# SERVICE INSTRUCTION

Service Instruction No. 1415A (Supersedes Service Instruction No. 1415) Engineering Aspects are FAA Approved

SUBJECT: New Turbocharger Mounting Hardware

MODELS AFFECTED: TO-360-C and -F series engines

Figure 1 New Turbocharger Mounting Components and Related Parts

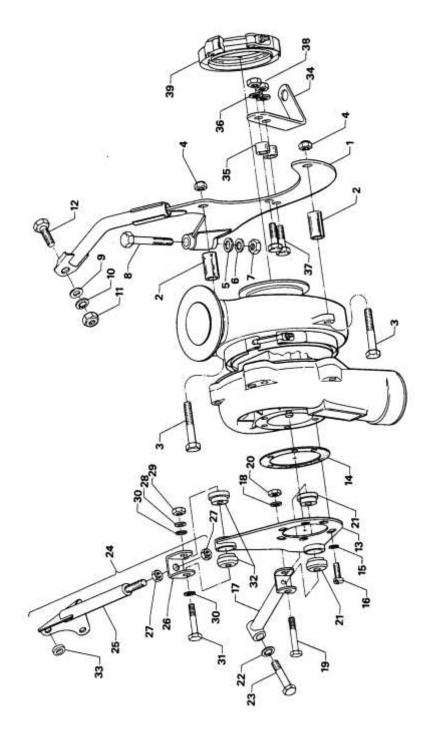
This Service Instruction identifies a new mount assembly P/N LW-18605, a new one-piece turbocharger bracket P/N LW-16757 and adjustable strut assembly P/N 07F23147 that are to be installed on TO-360-C and -F series engines.

The new bracket and strut arrangement will install at the same locations on the crankcase and accessory housing as the original mount system. Each individual bracket, strut, or mount assembly from this new system are compatible with the part or parts installed on the original mounting system. The new parts replace the superseded parts identified in Table 1.

The new bracket and strut are adapted for all engines identified in this Service Instruction. This new mounting arrangement gives a more stable mount and includes an adjustable strut for improved alignment of the mounting components. Installation instructions for the new parts also are included herein.

All the components and attaching parts must be installed as shown in Figure 1.

- 1. Remove and discard the mount assembly P/N LW-13961.
- 2. Install new mount assembly.
- 3. Install all mounting components.
- 4. Install all attaching parts.
- 5. Torque the mounting hardware as per the torque values in the latest revision of SSP-1776 Table of Limits.
- 6. Adjust the new strut assembly P/N 07F23147 to a no-load condition.
- 7. Safety the screws P/N STD-82 used to attach the mount assembly P/N LW-18605 and the gasket P/N LW-13476 to the compressor inlet of the turbocharger unit. The screws can be safety wired in sets of 3 or all 6 can be safety wired together.
